Access Compliance Report

Public Rights-of-Way

(Curb Ramps)

Intersection ID: 48943	Main Street: CALDWELL RIDGE PY	Cross Street: MORGAN LEE AV	Location: E
ADA ID: E260274942A0	Ramp Type: Perp	Initial Pass/Fail: Fail	Overall Compliance: No
		Severity Score: 8.75	
Codes/Mitigation Info/Possible Solution		Field Measurements/Component Compliance

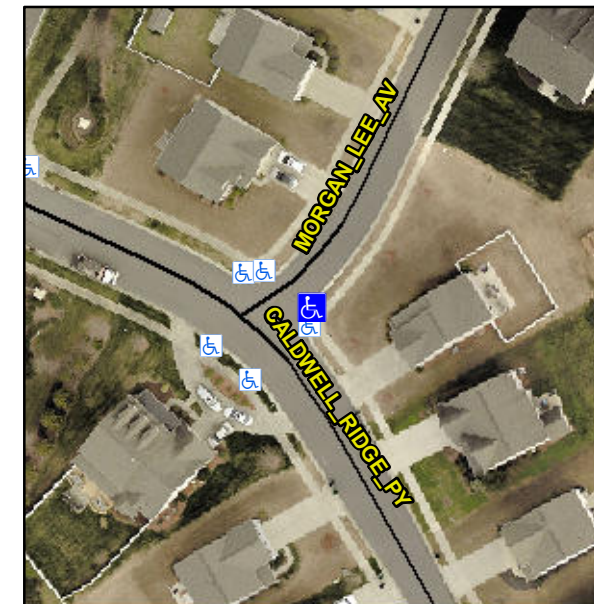
Not Found, R304.5.1

Compliance	Description	Data	Compliance	Description	Data
N/A	Ramp Length (in)	47.5	Yes	Ramp Slope (%)	6.5
No	Ramp Width (in)	47.5	Yes	Ramp XSlope (%)	0.6
N/A	Flare Type LT	N/A	N/A	Flare Type RT	N/A
N/A	Flare Slope LT (%)	N/A	N/A	Flare Slope RT (%)	N/A
N/A	Flare Traversable LT?	N/A	N/A	Flare Traversable RT?	N/A
N/A	Landing Length (in)	N/A	N/A	DWS Provided?	N/A
N/A	Landing Width (in)	N/A	N/A	DWS Contrast?	N/A
N/A	Landing Slope (%)	N/A	N/A	DWS Length (in)	N/A
N/A	Landing X Slope (%)	N/A	N/A	DWS Full Width?	N/A
N/A	Landing Curb? (Y/N)	N/A	N/A	DWS Offset (in)	N/A
N/A	Shared Landing?	N/A			
N/A	Gutter Ponding?	N/A	N/A	Gutter Slope (%)	N/A
N/A	Gutter Lip Ht (in)	N/A	N/A	Gutter X Slope (%)	N/A
N/A	Painted X Walk1?	No	N/A	Painted X Walk2?	N/A
	X Walk 1 Direction	To NW		X Walk 2 Direction	N/A
N/A	X Walk 1 Width (in)	N/A	N/A	X Walk 2 Width (in)	N/A
	X Walk 1 Slope (%)	1.2		X Walk 2 Slope (%)	N/A
	X Walk 1 X Slope (%)	1.6		X Walk 2 X Slope (%)	N/A

Remove & Replace Entire Ramp.
